REQUEST TO MODIFY A CONCEPT PLAN APPROVAL FOR A RESIDENTIAL SUBDIVISION AT ROSEDALE

Submissions Report (MP05_0199_MOD 2)

Bevian Road, Rosedale

April 2025

Figure 2: amendments made to southern part of the subdivision design between September 2024 to April 2025.

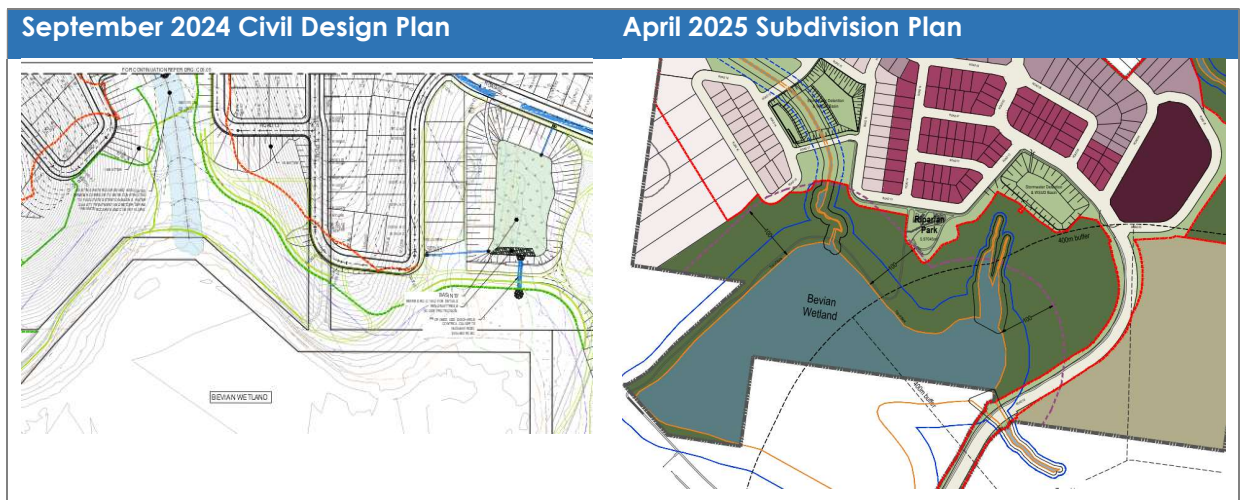
- Increasing the Bevan Wetland buffer zone from 50 metres to 100 metres, identifying that buffer area as a non-developable area, wherein civil design works, watercourse realignment, and associated ground level changes will not take place, nb. *There will, however, be limited incursions into the buffer only for necessary access roads.*

- Enhancing the extent and widths of the non-developable area adjoining Bevan Wetland will protect the sensitive foreshore environment and allow more room for natural regeneration to occur and establish over time. The discharge point and extent of the realigned watercourse and reconstructed vegetation riparian zone ("VRZ" ") works that had been proposed to drain directly into the NW edge of the Wetland have now been pulled back out to the 100m wide wetland buffer zone. These changes are illustrated in the following comparison plans.

3.7 The 100-metre-wide wetland buffer zone that has been created and will be protected as a "non-developable area under this Concept Plan". Has been achieved by the following amendments:

Figure 3: Revised Vegetation Mapping (April 2025)

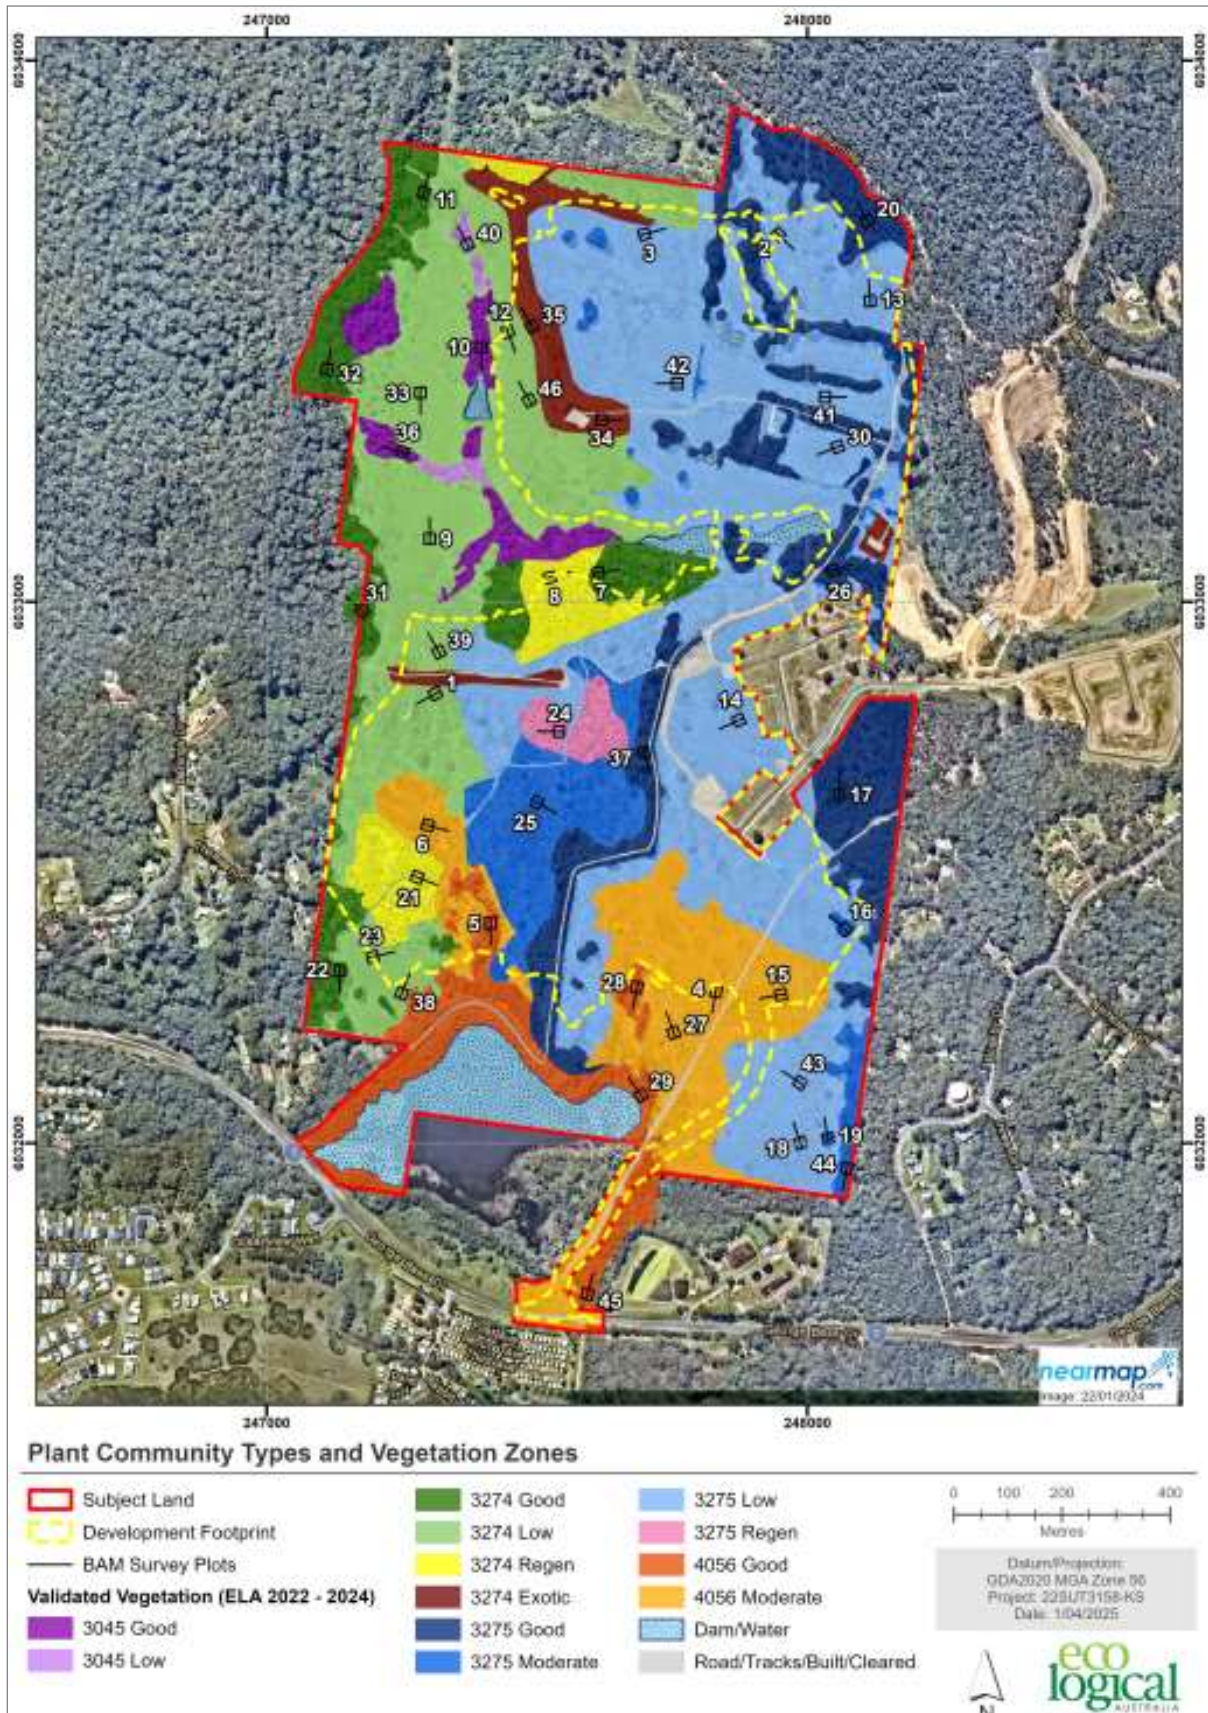
- 4.3 Furthermore, BCS contend there has been some mis-classification of vegetation between the South Coast Spotted Gum Moist Forest Community (PCT 3274) and the TEC plant community (PCT 4056).

- 4.5 In response, the site was revisited in January 2025—areas identified by BSC as potential TEC were investigated. The mapped land area occupied by PCT 4056 has consequently been increased from 21.13 Ha to 24.8 Hectares. (refer to Figure 4).

Figure 4: Revised Staging (April 2025)

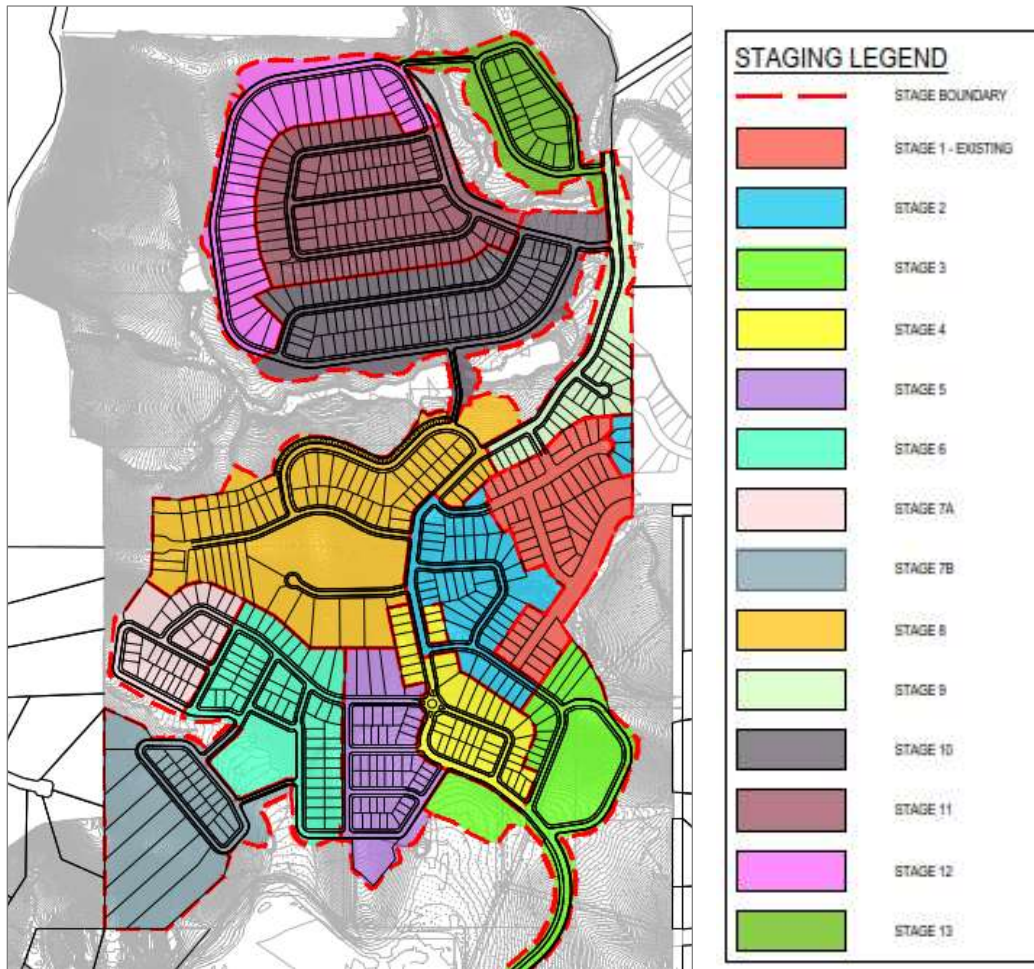
- 4.4 BCS also contended that a more generous buffer zone should be provided around the Wetland to provide a buffer to impacts of nearby urban development and enable natural re-establishment of the Wetland's ecological and biodiversity values.

- 4.12 The principal amendments to the Concept subdivision plan (refer to **Figure 4**) involved truncating the southerly extents of residential Stages 3, 5, and 7B, deletion of the Village Green recreation park (refer also to paragraphs **3.12-3.17** of this Report and **Appendix 5**), and rotating and reducing the area impacted by the proposed WSUD Basin, known as Basin B (refer to Civil design plans in **Appendix 8**). The proposed amendments to the approval process complement these physical changes by including a clear strategy to maintain the ecological values of the buffer zone by way of:

Figure 11: Proposed Intersection of Southern Access Road and George Bass Drive (Source: Enspire & Nearmap)

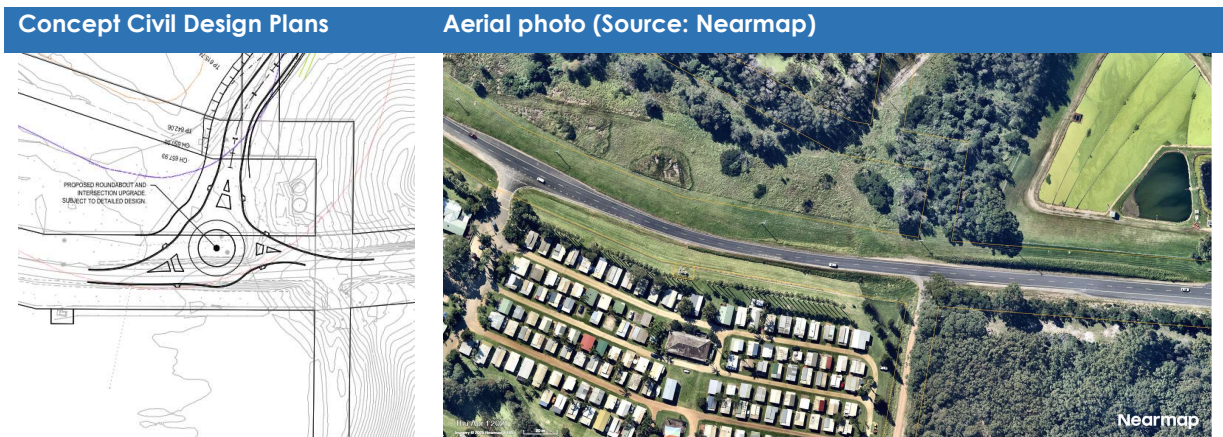
- 4.73 The Council has raised specific concerns that the siting and required design for the proposed roundabout will create traffic conflicts with vehicles attempting to access the Balrings Beach Access Track. The apparent very low usage of the Barlings Beach Access Track appears to be relevant to only a handful of vehicles at any one point. In that respect, it seems similar to movements associated with a single residential driveway.

- 4.75 The proposed location of the roundabout is therefore considered the optimum planning location because:
